Response to Submissions – SSD 6078

Oakdale Central – Horsley Park

Appendix A

Section 75W Modification Application (MOD 3) – MP08_0065 - Oakdale Central, Horsley Park (Lot 21 in Deposited Plan 1173181)

Estate Subdivision Plan

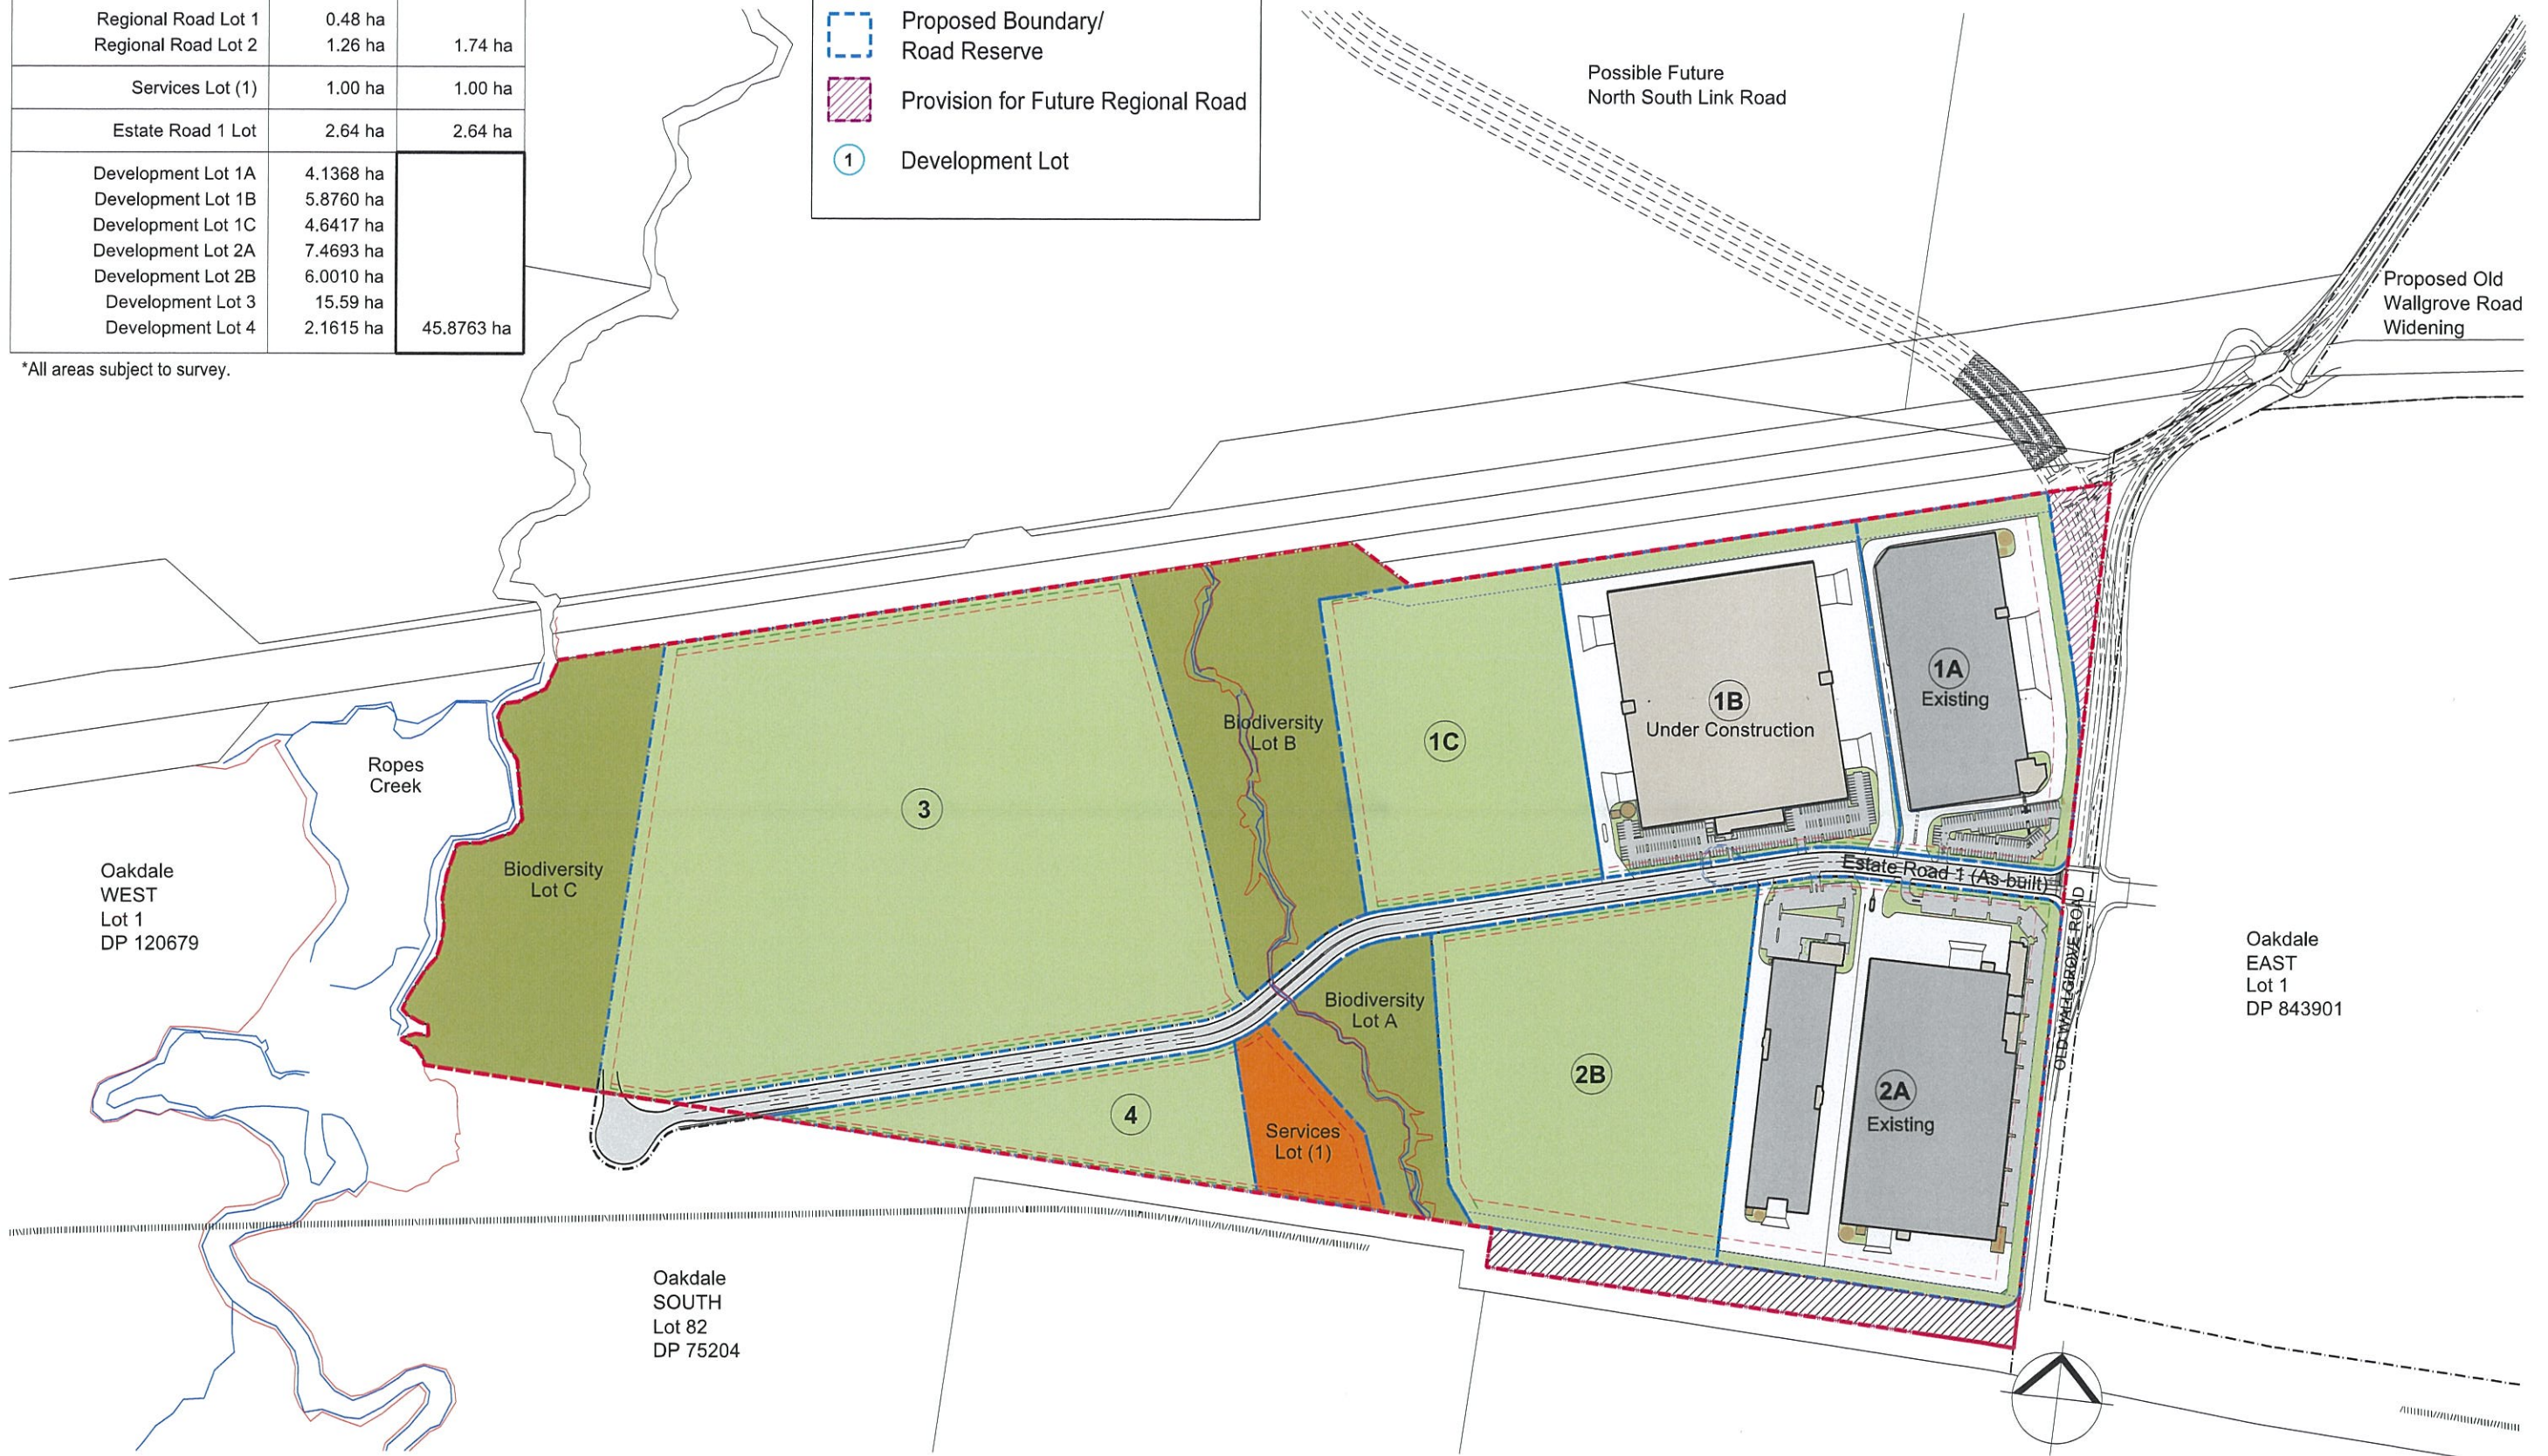
3. *With regards to the proposed amalgamation of Lots 3A and 3B into a single Lot 3, the following additional information is required:*

- *the "Subdivision Plan" is required to be amended by deleting the reference to Lots 3A and 3B, and replacing these with a reference to Lot 3 (including the total area of proposed Lot 3); and*
- *confirmation that the proposed boundary of the new amalgamated Lot 3 will remain the same as that of Lots 3A and 3B.*

Response: A revised Subdivision Plan has been prepared by SBA Architects and is annexed to this submission (see **Appendix 1**) which deletes reference to Lots 3A and 3B, amending the notation to "Lot 3" (plan reference **Subdivision Plan OAK DA 04 (B) 22 May 2014**). It is requested that this plan be referenced in Condition 1 under the General Terms of Approval.

The area of Lot 3 is proposed to remain unchanged from the Concept Approval with the resultant allotment size being 15.59 hectares. The alignment of Lot 3 will remain the same as was previously approved for Lots 3A and 3B and shall not encroach on the biodiversity lots.
